Project	<b>IEEE 802.16 Broadband Wireless Access Working Group</b> < <a href="http://ieee802.org/16">http://ieee802.org/16</a> >	
Title	<b>Changes on reference model to support PKM EAP message type</b>	
Date Submitted	<b>2004-03-05</b>	
Source(s)	Yong Chang/Ph.D Samsung Electronics	Voice: +82-31-279-3621 Fax: +82-31-279-1234 <a href="mailto:yongchang@samsung.com">mailto: yongchang@samsung.com</a>
Re:	This is a response to a Call for Comments IEEE 802.16e-04/xxx	
Abstract	This document contains suggestions to change the protocol reference model reflecting Security Adhoc working groups agreements on the PKM EAP message type	
Purpose	The document is submitted for review by 802.16e Working Group members.	
Notice	This document has been prepared to assist IEEE 802.16. It is offered as a basis for discussion and is not binding on the contributing individual(s) or organization(s). The material in this document is subject to change in form and content after further study. The contributor(s) reserve(s) the right to add, amend or withdraw material contained herein.

# Changes on reference model to support PKM EAP message type

Figure 1—IEEE Std 802.16 protocol layering, showing SAPs

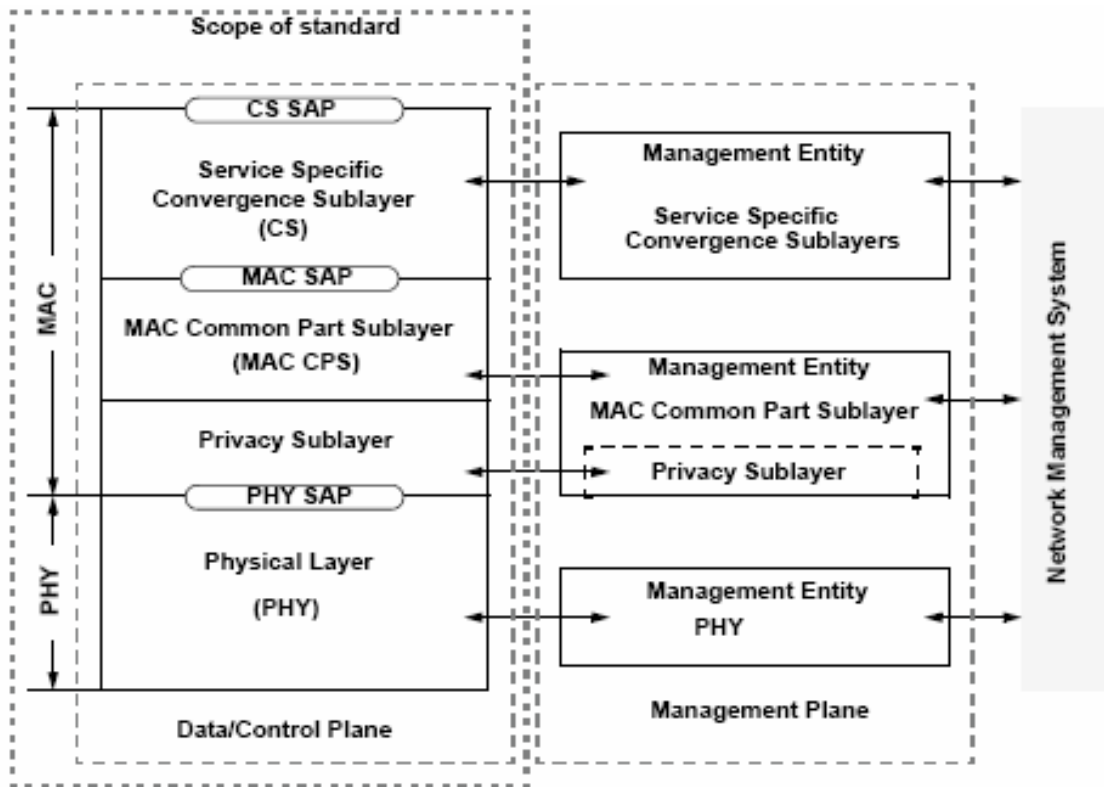
Due to the Security Adhoc working group’s agreement on the EAP-based Authentication support, the reference model diagram in the section 1.4 should be changed appropriately. Current Data/Control Reference model depicting Privacy sublayer under the MAC CPS has inconsistency with Control plane Privacy sublayer functionality. We propose change on reference model diagrams with separate Data and Control plane diagram. The Data and Control plane diagram is reflecting the comment resolutions of the last meeting and TGe baseline text IEEE 802.16-71/r4.

[Replace Figure-1 to the following]  
 [From:]

[To:]
